ENGINE — PROVIDE NEW TURBINE COOLING AIR (TCA) ORIFICE PLATE TO IMPROVE THRUST SPECIFIC FUEL CONSUMPTION (TSFC)

Turbojet Engine Service Bulletin No. 72-631 Revision No. 1 dated August 16, 2016.

SERVICE BULLETIN

V2500-ENG-72-0631

LOCATION OF THE ORIFICE PLATE
72-45-21
FIGURE 1

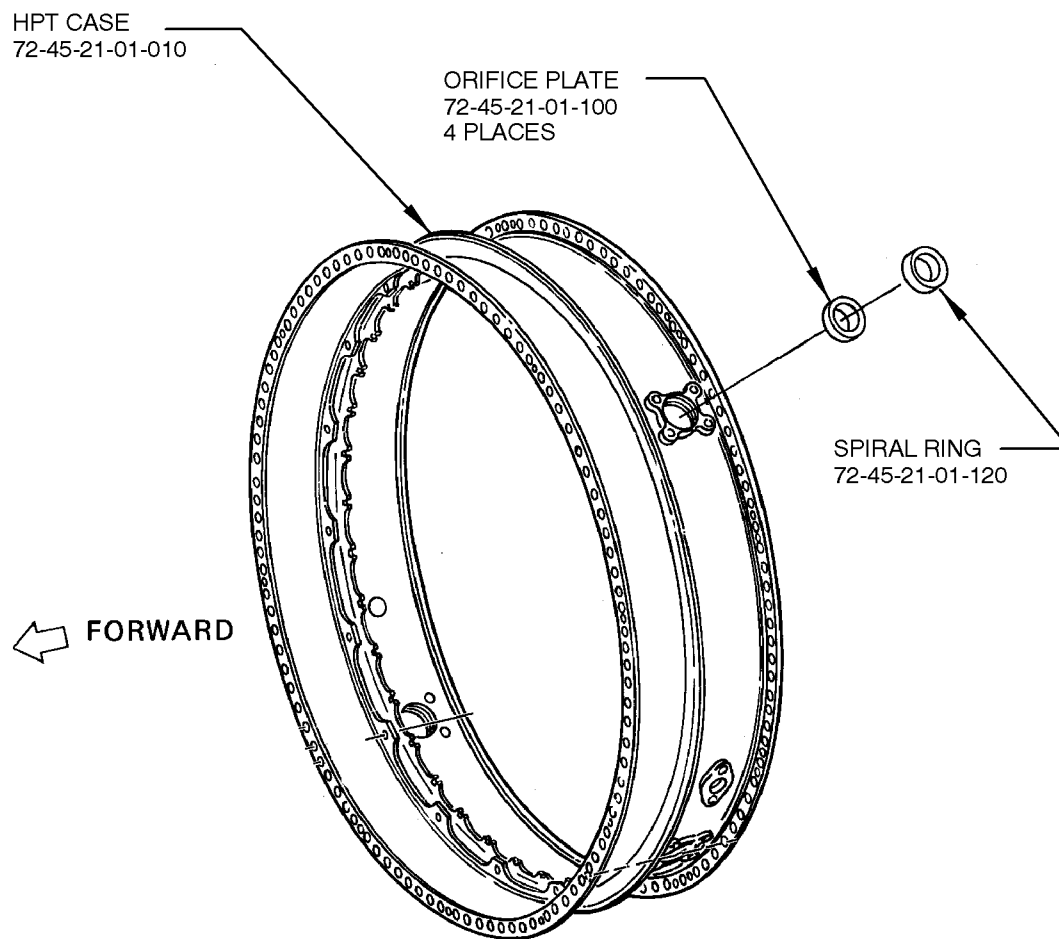
1. Replace the HPT Case And Vane Assembly, PN 2A4087 with PN 2A4387 or do a modification of the HPT Case And Vane Assembly, PN 2A4087 or PN 2A4087-001 as follows: See Figures 1 and 2.
 - A. Remove the old Orifice Plate, PN 2A3738 (4 off), from the four bosses on the outer diameter of the HPT Case and Vane Assembly.
 - B. Replace the Orifice Plate, PN 2A3738 with PN 2A3739.
 - C. Install the new Orifice Plate, PN 2A3739 (4 off) on the four bosses of the HPT Case and Vane Assembly per Reference 6, V2500-A5 Engine Manual TASK 72-45-20-440-002-C00, Subtask 72-45-20-440-134.
 - D. Reidentify the HPT Case And Vane Assembly per Table 1. Mark the new part number per Reference 7 Standard Practices/Processes Manual, Chapter/Section 70-09-00, marking of parts. See Figure 3 for the location of marking. Use vibropeen method (manual or mechanical).

MARKING LOCATION OF THE HPT ROTOR AND STATOR ASSEMBLY
FIGURE 4

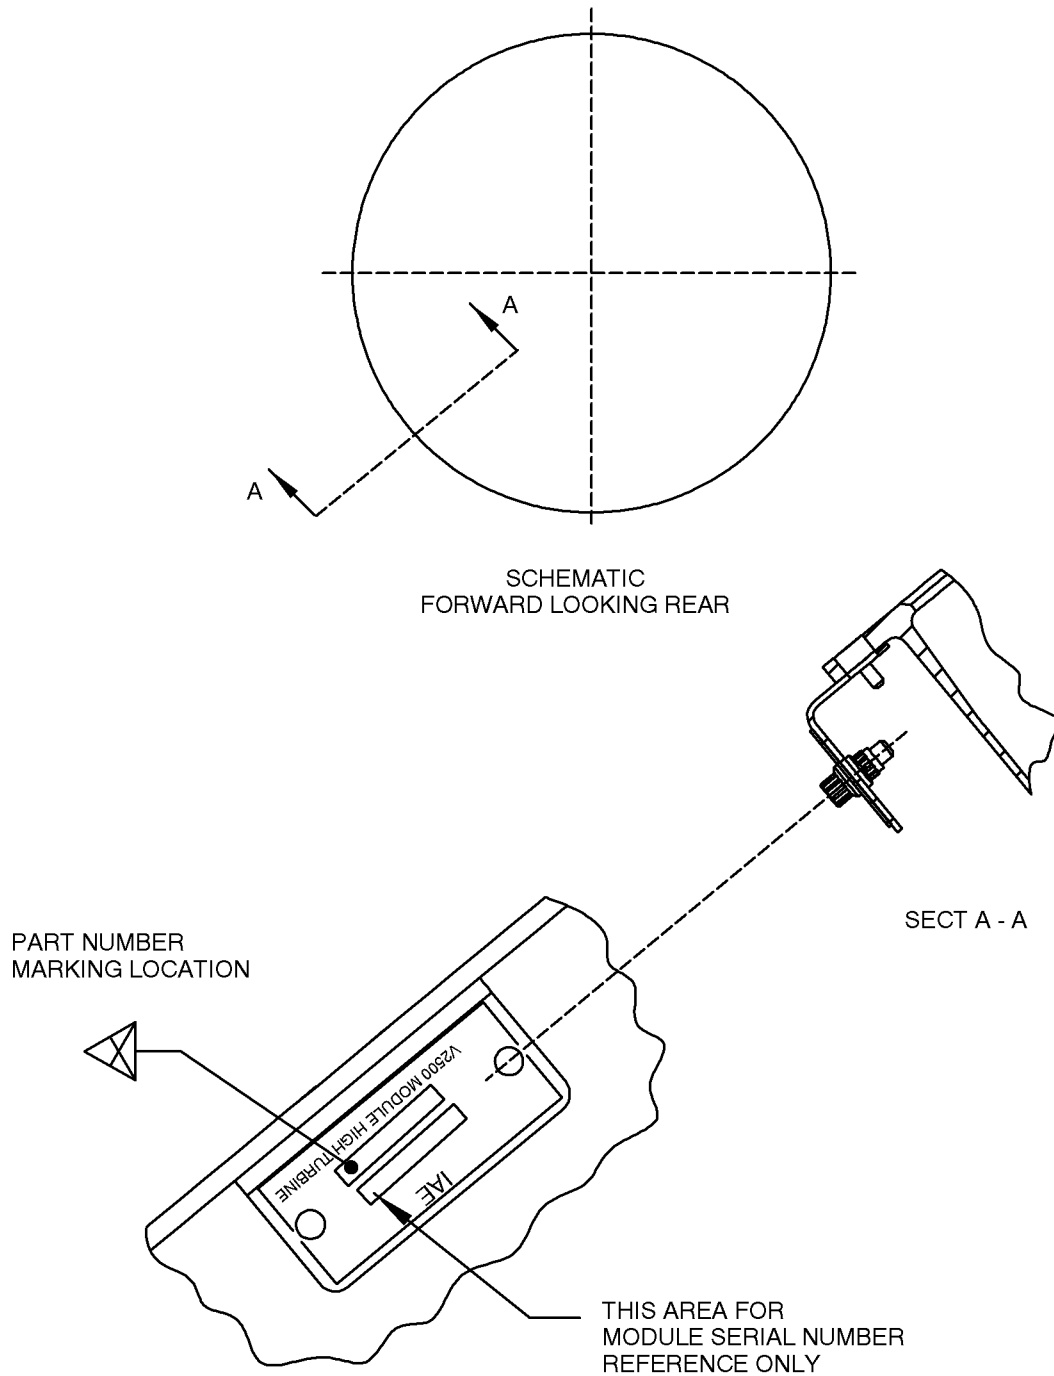
- E. Reidentify the HPT Rotor And Stator Assembly per Table 2. Mark the new part number per References 7, Standard Practices/Processes Manual, Chapter/Section 70-09-00, marking of parts. See Figure 4 for the location of marking. Use vibropeen method (manual or mechanical).

New PN	Old PN
2A4350	2A4250
2A4250-002	2A4250-001
